14TH & MADISON
1401 EAST MADISON

DESIGN REVIEW RECOMMENDATION #2
DPD #3020065 / 27 JULY 2016

ARRANGEMENT OF
USE PLAN DIAGRAMS

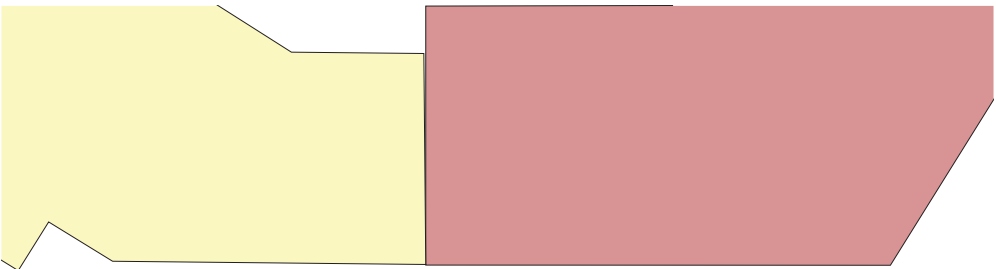
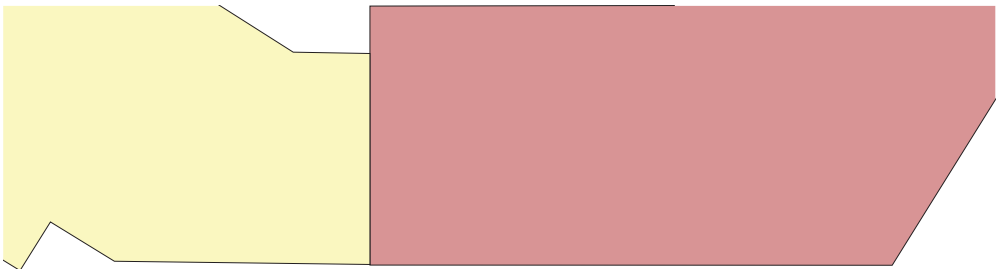
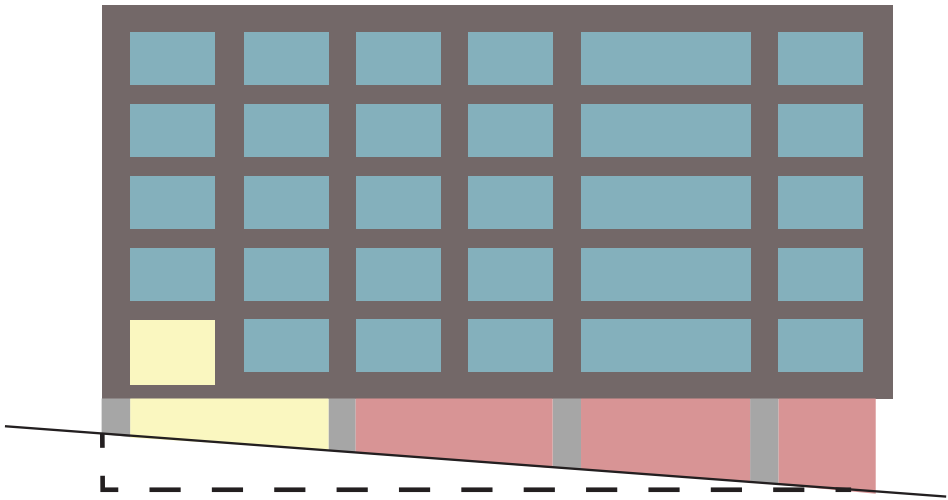
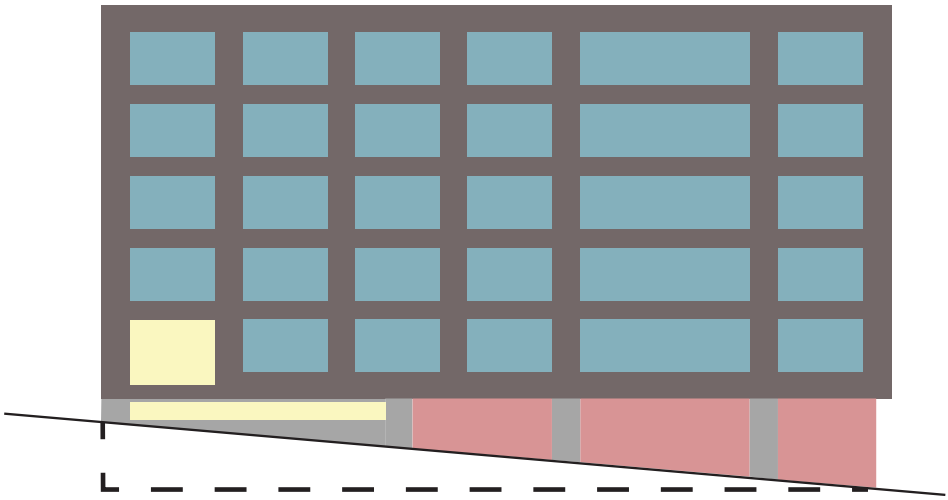
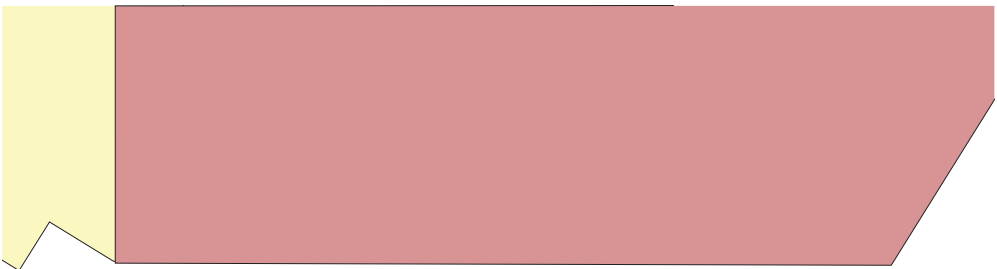
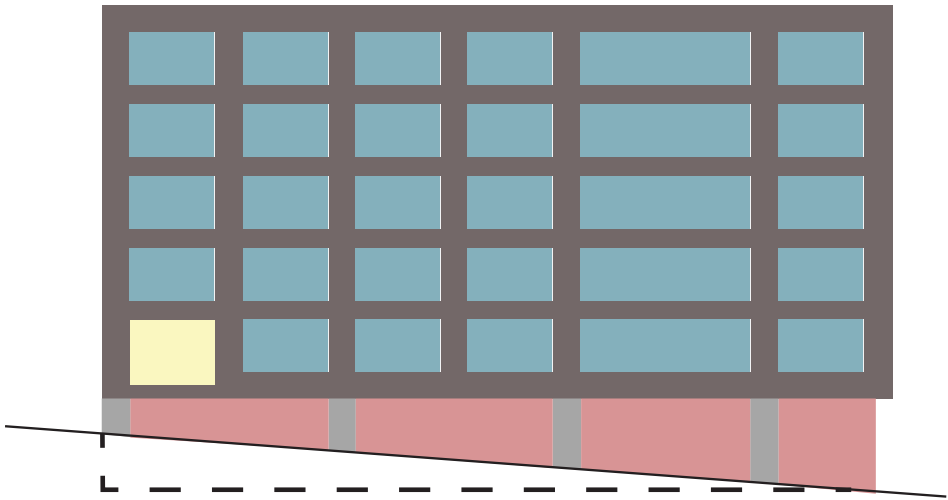
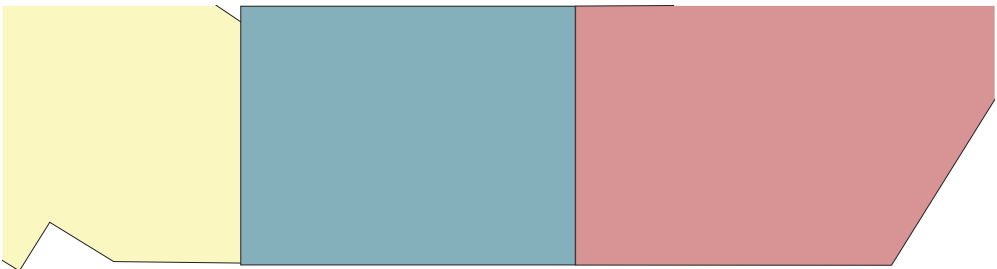
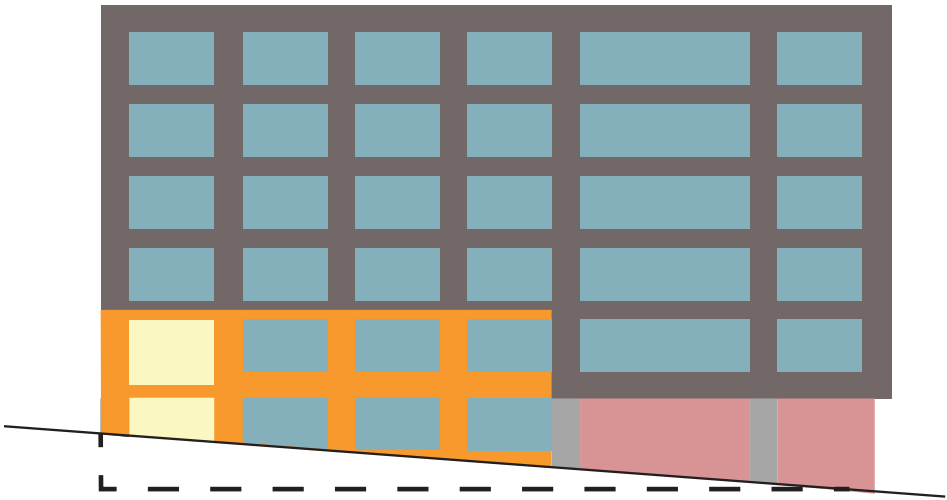
- a. The Board stressed that addressing the street and the relationship to the pedestrian is critical and directed the applicant to develop a strong connection to the street, study the arrangement of interior uses and significantly increase the transparency to provide visual access for the pedestrian.

We studied the arrangement of uses and increased the retail frontage by **6** additional feet along Madison.

We also increased the setback along the Madison frontage simultaneously widening the sidewalk and allowing for multiple entry points, helping to strengthen the connection to the street.

PREVIOUS DESIGN: Transparency at Madison: 485 SF

NEW DESIGN: Transparency along Madison: 768 SF

A significant increase of glazing of **159 percent** to provide visual access for the pedestrian.

L1 PLAN

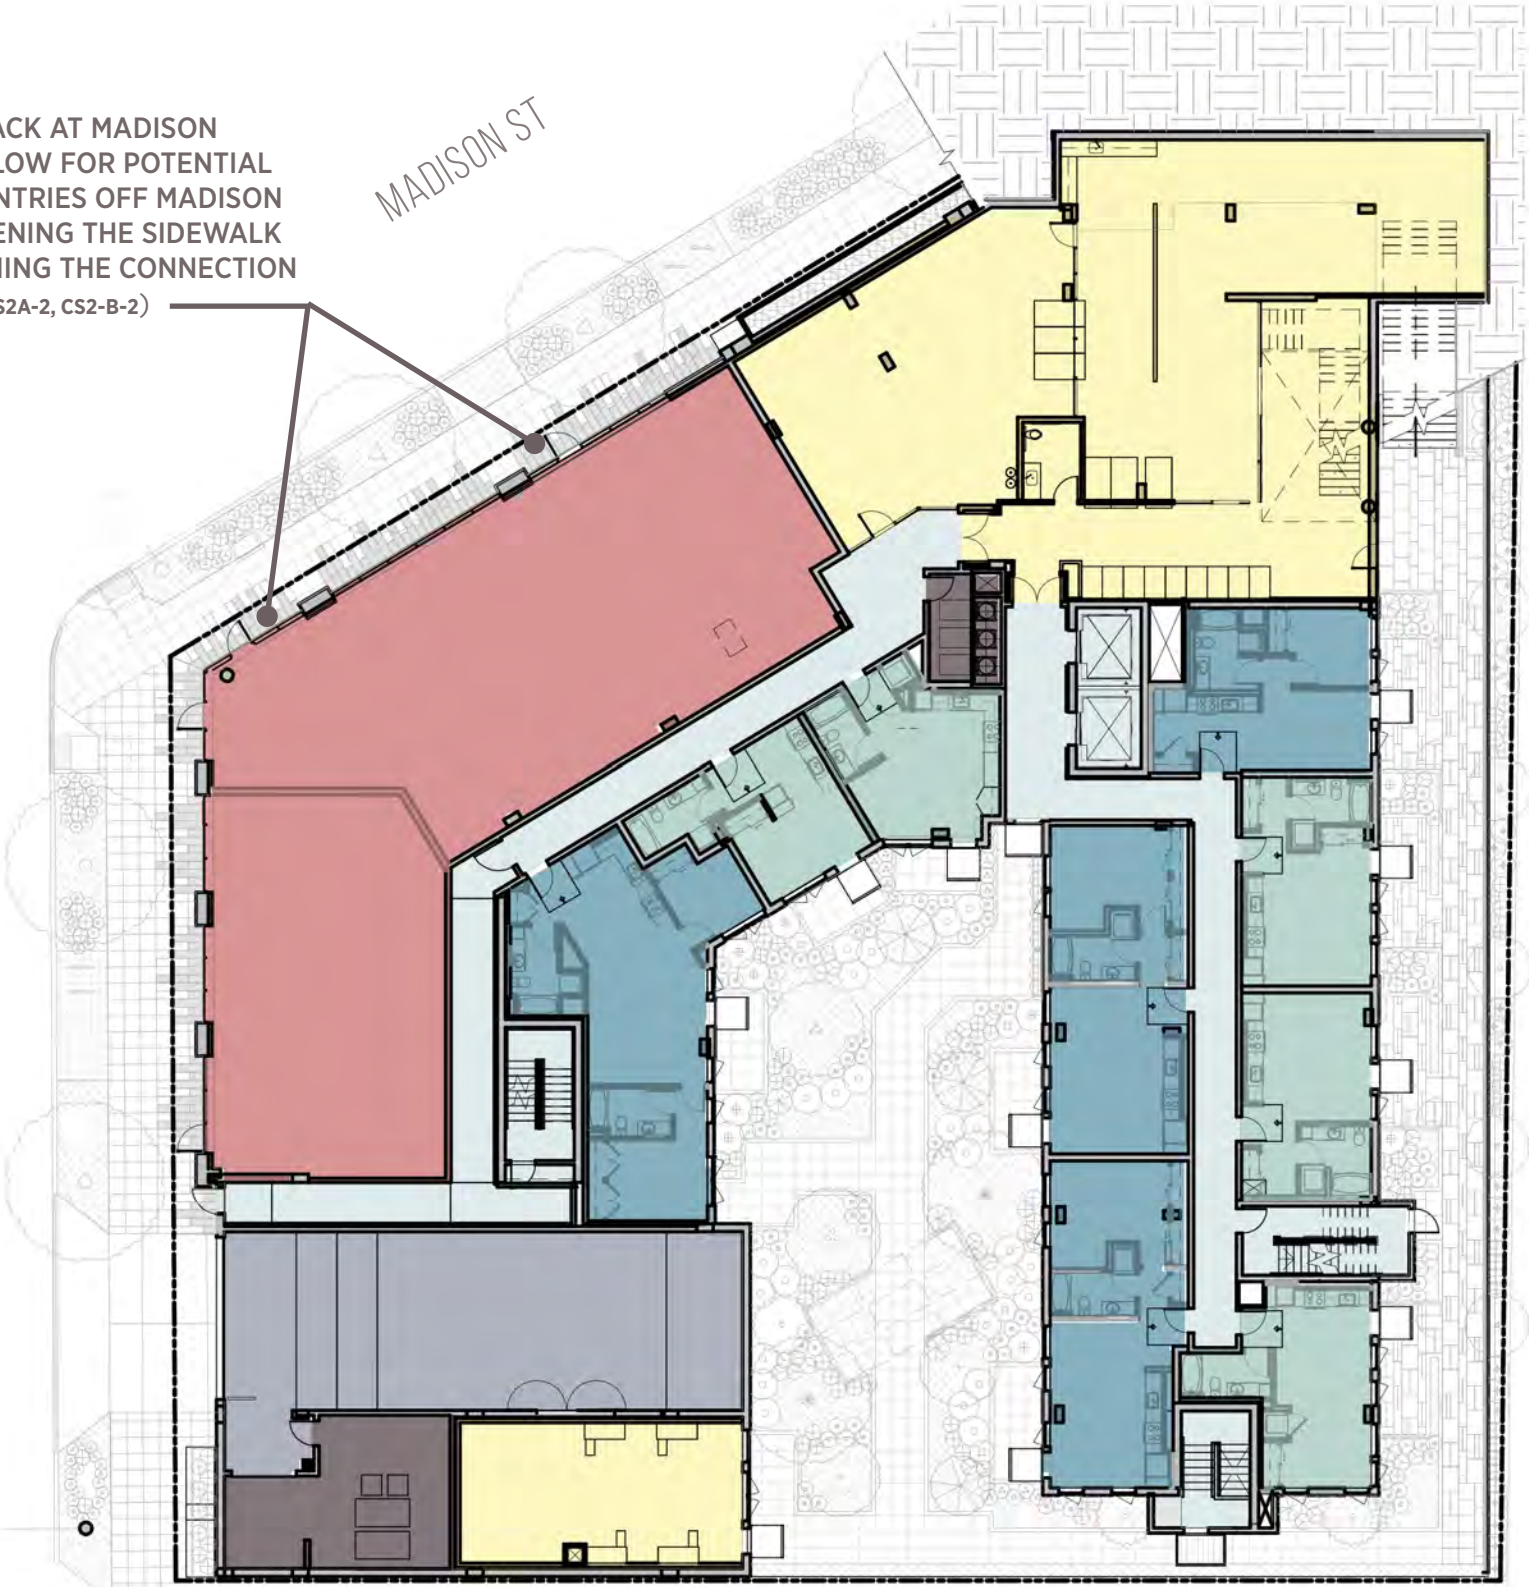
- b. For the corner, the Board agreed that retail spaces at grade is preferable. The Board also indicated support of second level entries off Madison to strengthen the connection to the street. For the next meeting, the Board requested a composite site plan.

Created additional entries off Madison, strengthening connection to the street.

Composite site plan provided. Landscape plan diagram for reference.

L1 and L2 plans also provided.

INCREASED SETBACK AT MADISON FRONTAGE TO ALLOW FOR POTENTIAL SECOND LEVEL ENTRIES OFF MADISON WHILE ALSO WIDENING THE SIDEWALK AND STRENGTHENING THE CONNECTION TO THE STREET (CS2A-2, CS2-B-2)

OPTION A:

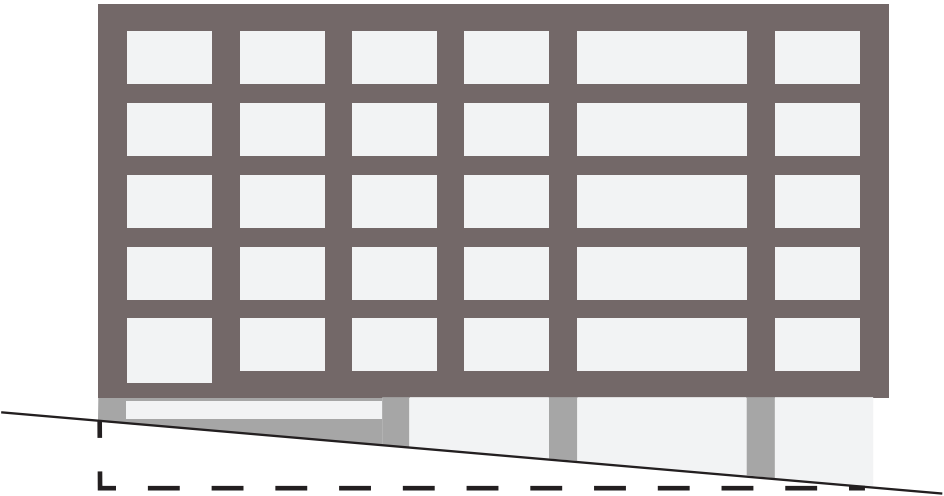
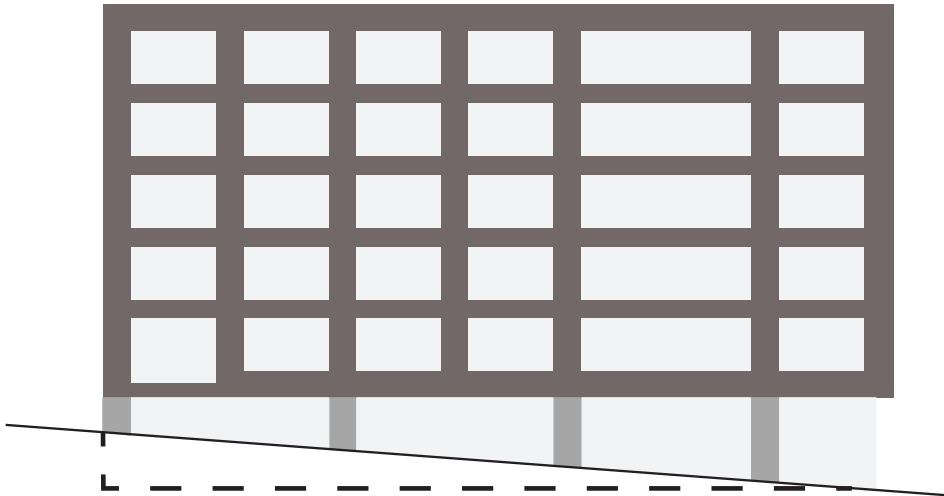
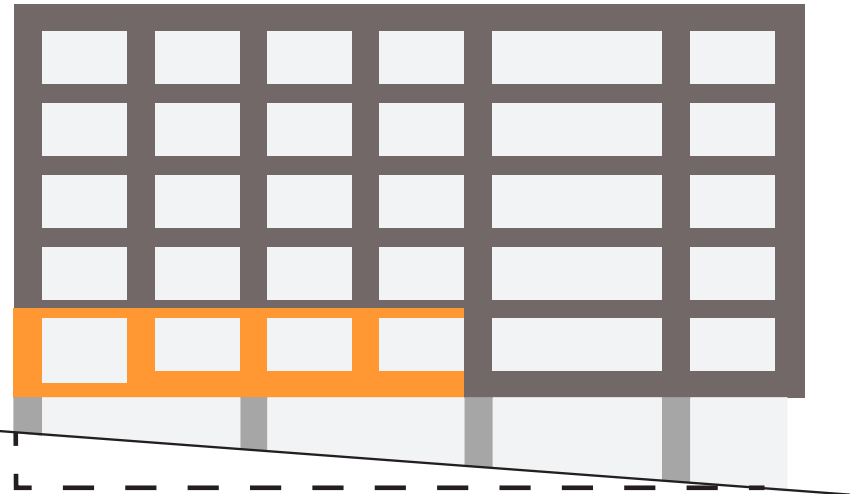
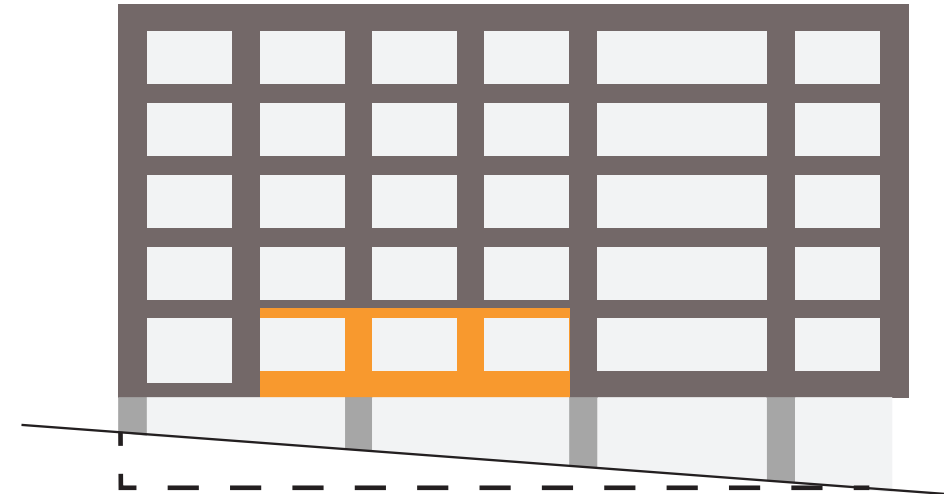
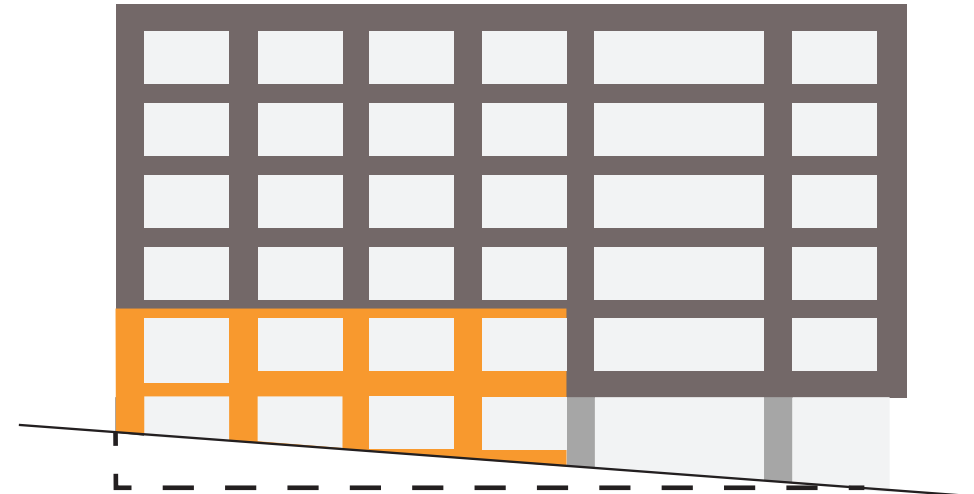
- a. The Board discussed the design development of the two scales, the ‘urban edge’ and the ‘private mews’ and their respective street frontages and noted that differentiating the outward expression of the residential lobby and the retail uses is not a high priority as the building will function as one building. The Board recommended further study of the façade including the proportions of the white cladding to storefront. The Board indicated that stepping the facade should read as a strong intentional design move and should be more than a rectangular cut in the white cladding. The Board also recommended pulling the language of the triple height atrium around to Madison.

Per Board recommendation, we have provided studies of the façade that show the white portion of the project stepped. These options lack the simple, uniform clarity the planes provide the streetscape. As indicated on pages 4-7 of this packet, a change to the simple, floating pure rectangular element is inconsistent with the project’s overall concept (DC2-B-1, CS2-A-2, DC2-C-1).

OPTION A: UNIFORMITY AT THE BASE - PREFERRED

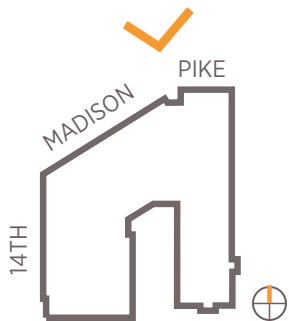
- a. ...The Board also recommended pulling the language of the triple height atrium around to Madison.

We have provided a study of the facade with the storefront expression of the mews brought to Madison.

Option A: Our preferred option is to keep the storefront at the base, knitting the private mews and urban edge expressions together, and highlighting the activity within the lobby spaces. (DC2-B-1, DC2-C-1)

Option B: The proportions are not as elegant. It detracts from the transparency at the base, and creates unnecessary attention to an element that does not call for it. (DC2-B-1, CS2-A-2)

OPTION A: BLACK FIN WITH BLACK WINDOWS - PREFERRED

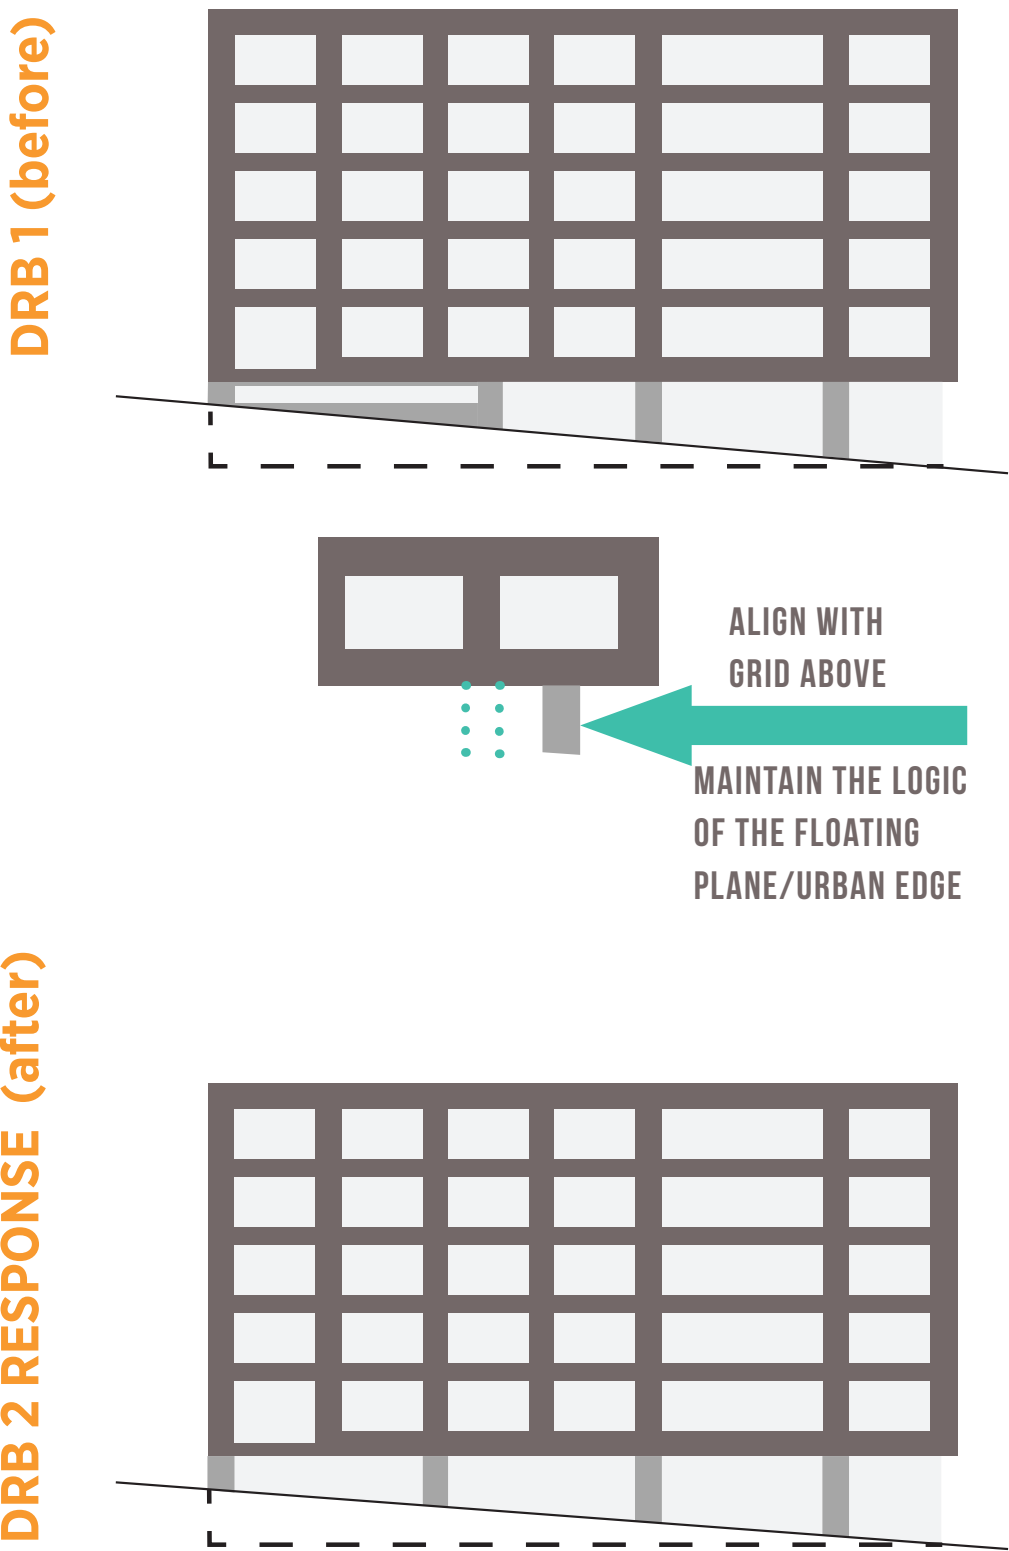
b. The Board struggled with finding the logic of the upper façade along Madison and agreed that the fenestration repetition creates an appearance of a hospitality function. The Board directed the applicant to focus on articulation consistent with the overall architectural concept. The Board also recommended studying window fin color treatment and noted their preference for at least 6 inches of depth.

One Board member mentioned that the fenestration repetition created the appearance of a hospitality function. This comment is unclear and does not relate back to the Design Guidelines. There are no universal hospitality or residential fenestration standards, and there are several window types and configurations located across the facade: 1. double casement/ fixed, 2. fixed/ double casement, 3. single casement, 4. double casement. Additionally, the fenestration becomes more varied when the units are inhabited: blinds/curtains up/down, casements open/closed. The building serves as backdrop for the variation in life. It is a fabric building, not a monument.

Per Board comments, we did focus on articulation at the ground floor consistent with the architectural concept by maintaining the logic of the grid across the facade, keeping the floating plane intact (**DC4-A**).

Shade fin is 6 inches in depth minimum (**DC4-A**).

Per Board recommendation, we have studied fin color treatments. Our preferred option is using the black metal fin, as the white fin is not as elegant nor does it frame the window as sharply.
